## Product Change Notice

PCN#: EE-PCN23017

KR-5R5V105-R
KR-5R5V155-R

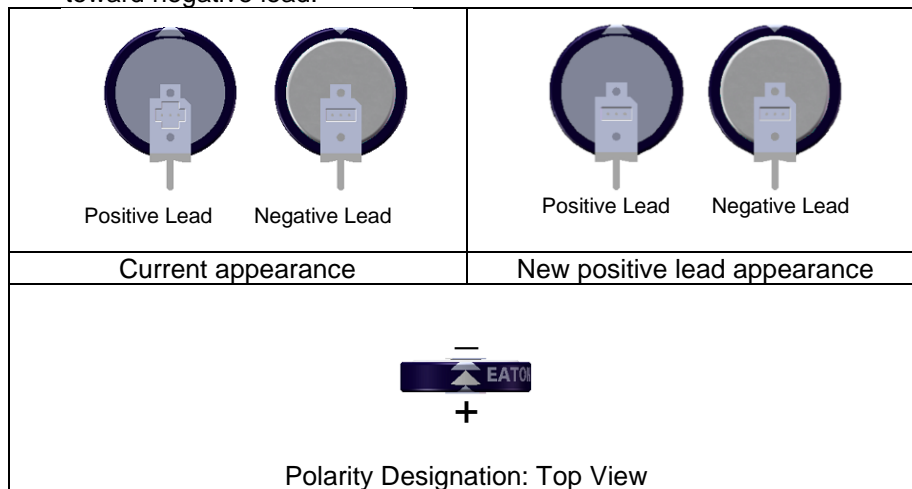
1. Tolerance of dimension P changing from  $\pm 0.3$  mm to  $\pm 0.5$  mm
2. Change of positive lead appearance. Polarity will continue to be determined by sleeve design pointing toward negative lead.

1. Specification to match actual production.
2. Quality improvement to avoid confusion with marking on the lead.
